Staff Report to the Zoning Administrator

Application Number: **05-0126**

Project Description: Proposal to demolish two commercial buildings and construct an approximately 2,700 sq. ft. restaurant with studio apartment above.

Location: 900 - 41st Avenue, Santa Cruz

Canton Restaurant: View from 41st Avenue

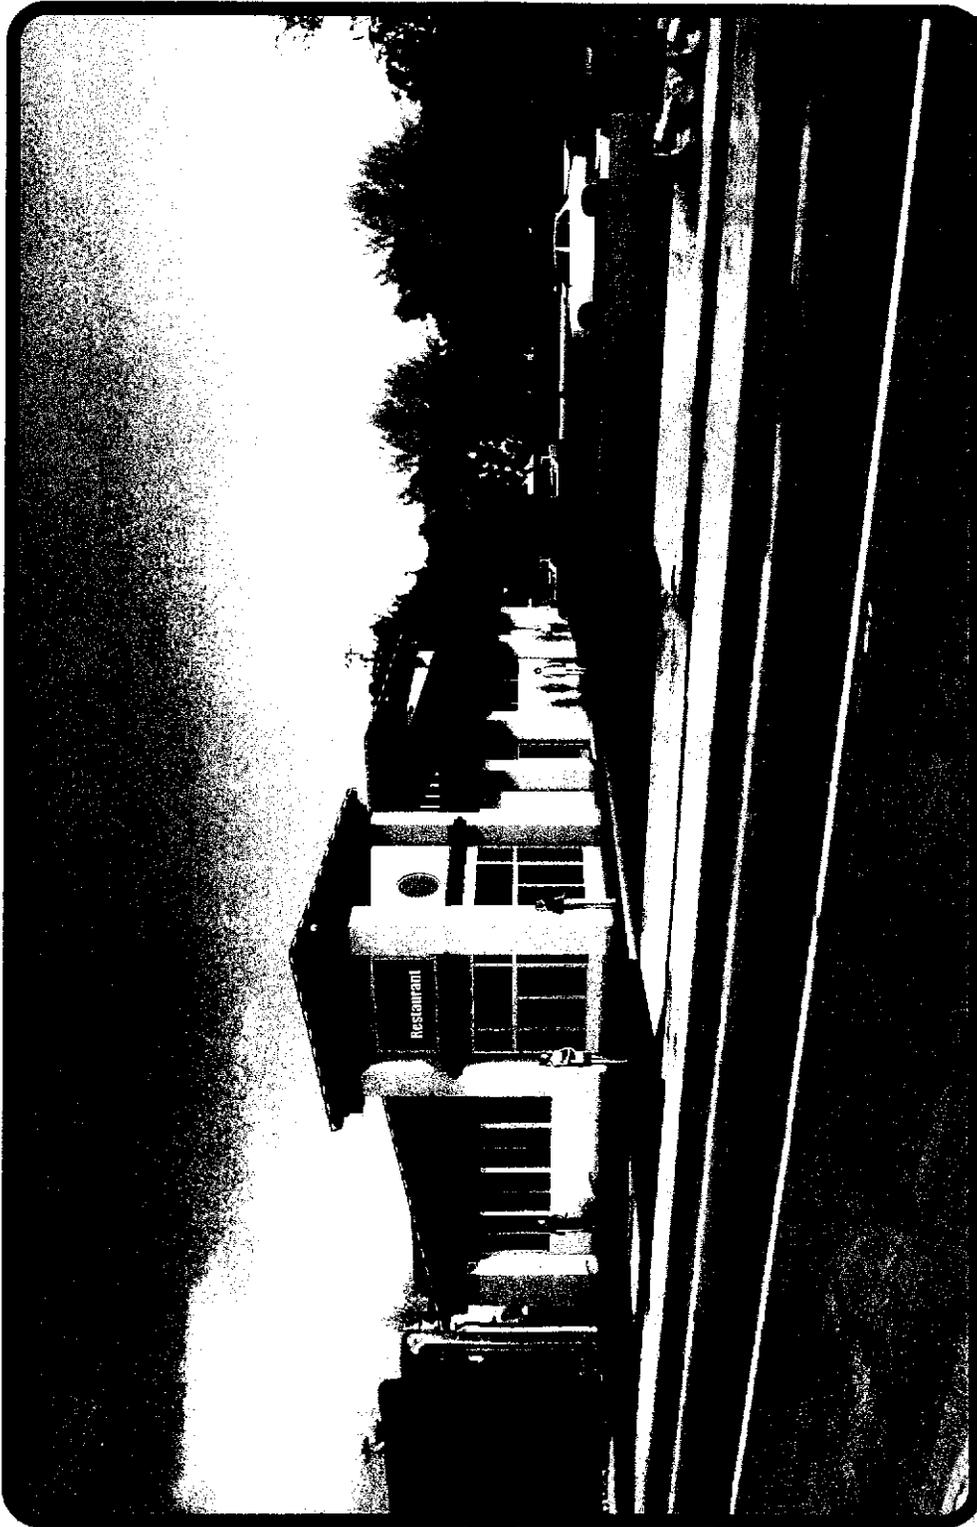
7. The North Elevation of the building has been changed since the last submittal, with all of the windows being removed. RDA recommends that windows or other architectural features be added to this elevation to break up the mass of this blank wall.
